UNITED STATES ATOMIC ENERGY COMMISSION
DIVISION OF REACTOR LICENSING
REPORT TO ADVISORY COMMITTEE ON REACTOR SAFEGUARDS
IN THE MATTER OF
CONSOLIDATED EDISON COMPANY OF NEW YORK, INC.
INDIAN POINT NUCLEAR GENERATING UNIT NO. 2
REPORT NO. 4

The attached report has been prepared by the Division of Reactor Licensing for consideration by the Advisory Committee on Reactor Safeguards at its Special August 1966 meeting.

Figure 1

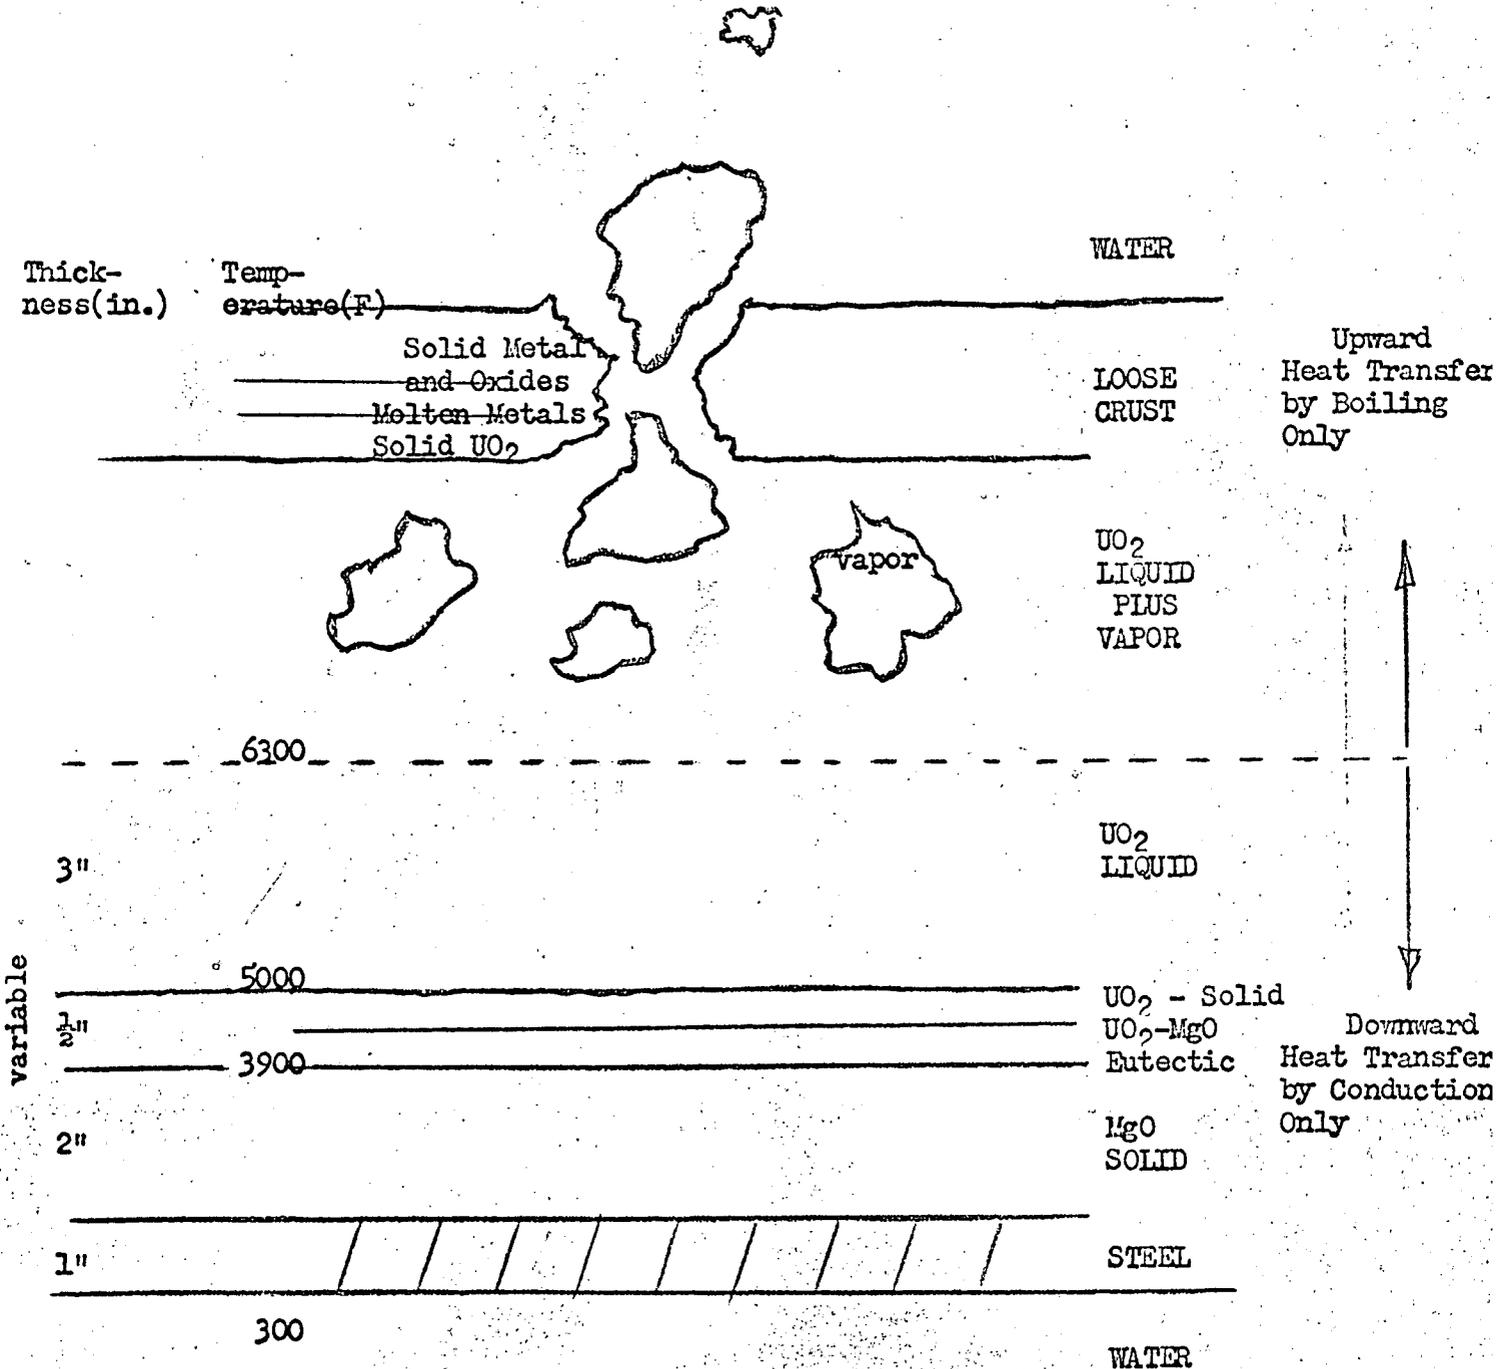
1. The applicant has presented a limited amount of material and without some of the detail necessary for a definitive evaluation of even the basic concept.
2. Rather limited heat transfer models and arguments are used.
3. The limiting or significant parameters are not noted.

1. An evaluation of the concept requires further information regarding the fundamental heat transfer mechanisms (which may not be easily obtainable).
2. The model presented is highly sensitive to the amount of heat transfer downward through the bottom of the crucible. As the heat flux increases, the steel temperature increases and the amount of remaining

refractory material decreases (MgO above 3900F is assumed to float to the top of the melt). The applicant's simplified approach for evaluating this quantity leaves much to be desired.

3. The applicant does not state, nor do we know, the limiting thickness of refractory material necessary or the limiting steel temperatures before failure of the crucible can be assumed.

Figures 1 and 2 summarize the applicant's model and the results of our independent calculations using the model. Figure 1 presents the basic model with necessary explanatory information. Figure 2A shows the thickness of refractory remaining and the maximum steel temperature (at MgO-steel interface) as a function of downward heat flux. Figure 2B shows the downward heat flux as a function of percent of full power (decay heat rate) and the parameter "k." This parameter is the assumed conductivity of liquid UO_2 which is used in the simple conduction model for estimating downward heat transfer. As we increase the value of "k," we are essentially assuming added heat transfer mechanisms in the downward direction (due, for example, to convection currents). With the information we presently have available, it is difficult to predict the value of "k" which should be used in a simple conduction model. The applicant proposes to use a maximum value of 5.2 Btu/ft-hr-F which is two times their presently accepted value for conductivity in solid UO_2 at the melting point. Considering the model assumes liquid UO_2 with convection currents, this value does not appear to be unduly conservative.

Figure 2A
Steel Temperatures and Refractory Thickness

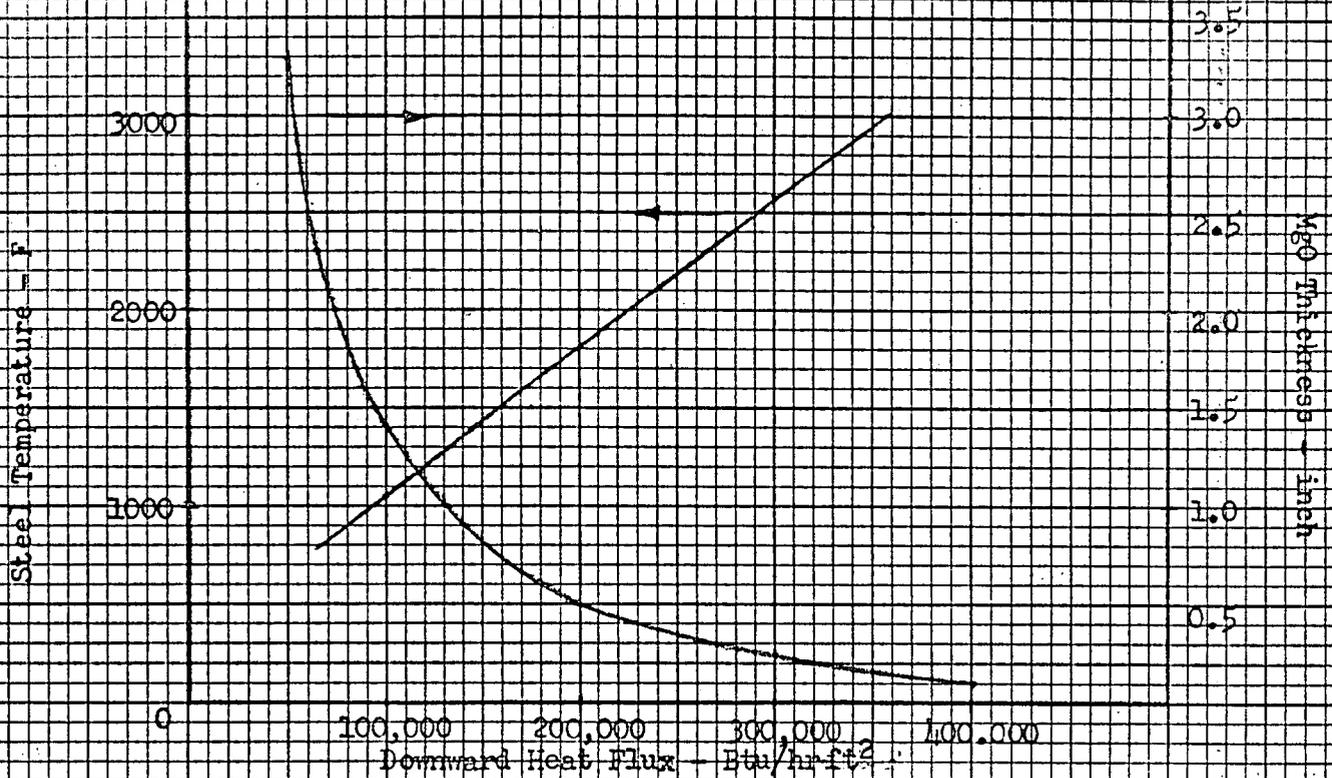
In summary, we do not believe that the applicant has presented sufficient detail or analysis to demonstrate that the reactor pit crucible will function in the manner anticipated. However, we believe that installation of the crucible will not reduce the safety of the facility.
